UNION ELECTRIC COMPANY
1901 GRATIOT STREET
ST. LOUIS, MISSOURI

ULNRC-636
SUBJ: Integrated Design
Inspection 50-483/82-22

Ref: NRC Letter DeYoung To Schnell, Union Electric, Dated 4/4/83:
Subj. As Above

In accordance with the reference request, please find enclosed Union Electric's response to the findings and unresolved items identified in the subject design inspection of the SNUPPS/Callaway Auxiliary Feedwater System. The order of response has been arranged to coincide with the sequence used by NRC in the reference report. For purposes of brevity, specific inspection findings and unresolved items have, in most instances, been paraphrased rather than repeated in their entirety.

Det. 17, Dwg. C-0418

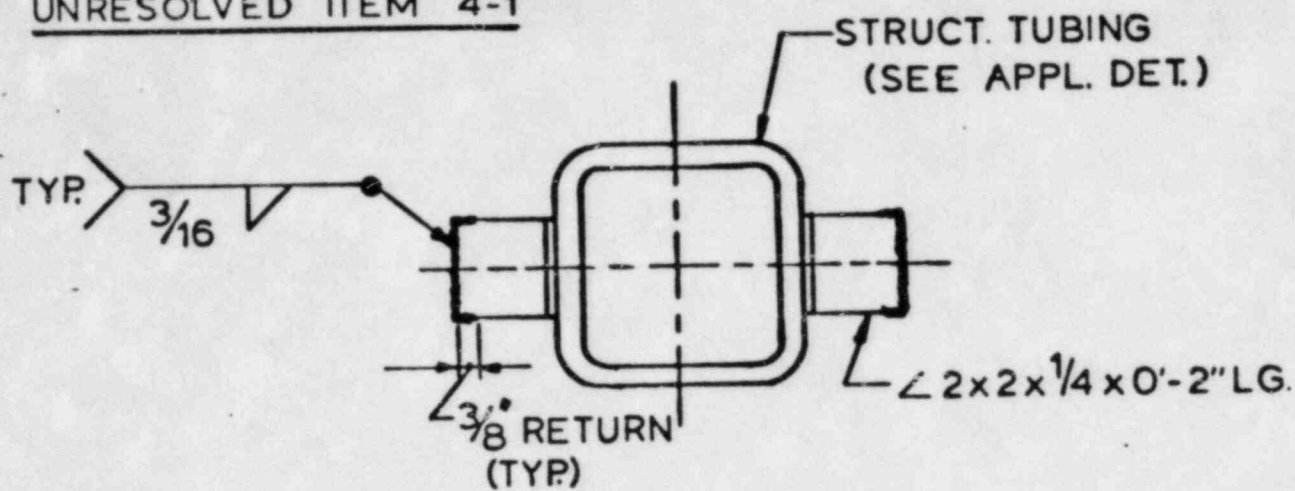
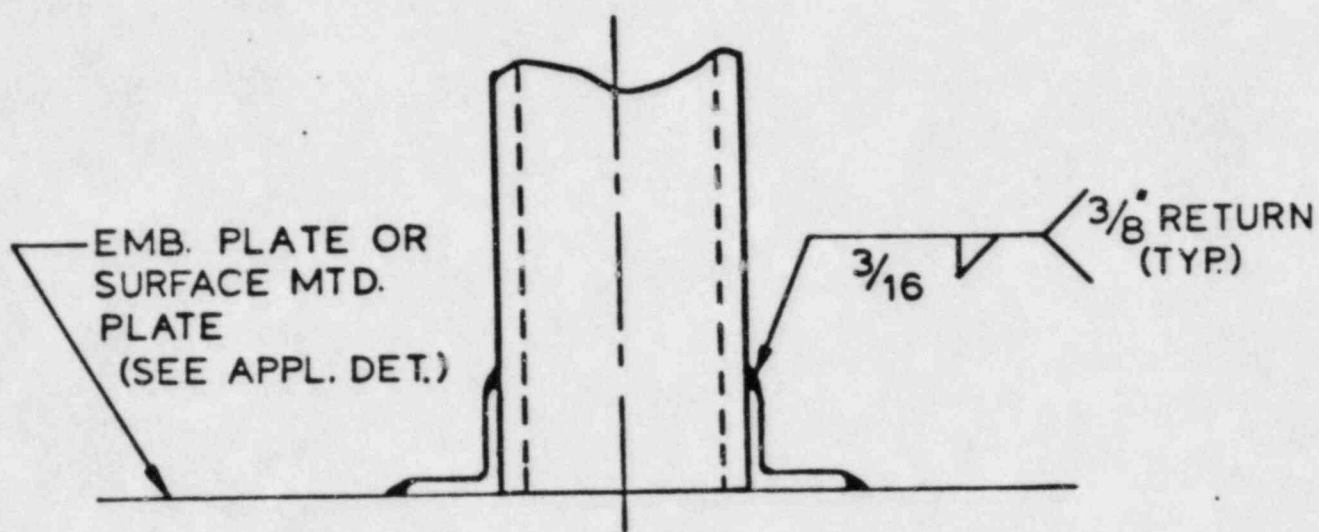
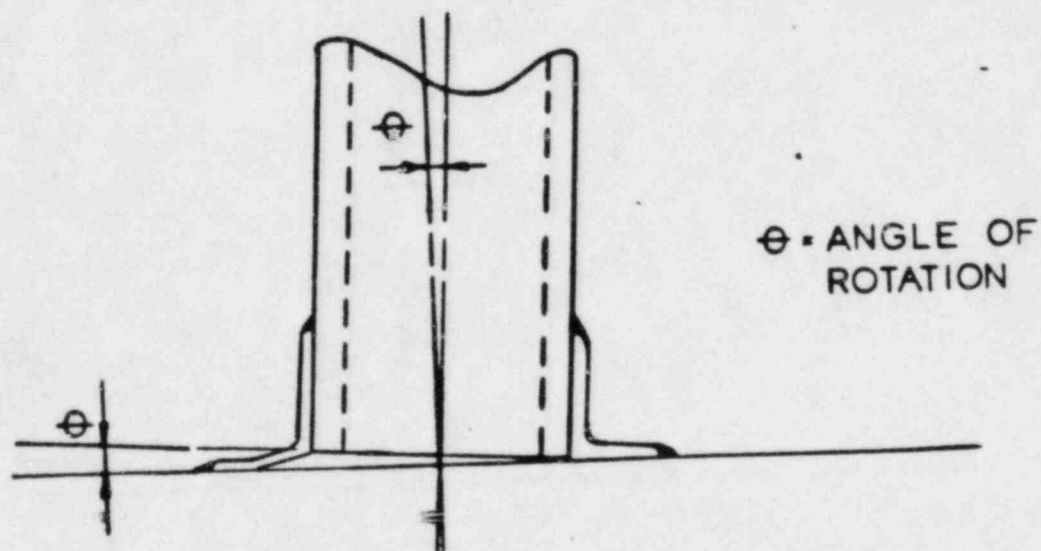
In the design of an electrical raceway support involving the use of clip angles connecting a vertical steel tube to a base plate, assumptions regarding a hinged connection at the base were questioned. The design did not account for partial fixity developed at this connection. It was requested that the welds and angles be evaluated in terms of actual fixity of the attachment to determine whether or not adequate strength exists.

The subject connection detail was utilized in the design of cable tray supports located within the Auxiliary and Control buildings involving tubular steel members spanning between floors. The detail in question consists of two, 2" x 2" x 1/4" steel angles, two inches in length, field welded to the steel tube and a surface mounted or embedded base plate at the floor surface. The details are shown on the design drawings as follows:
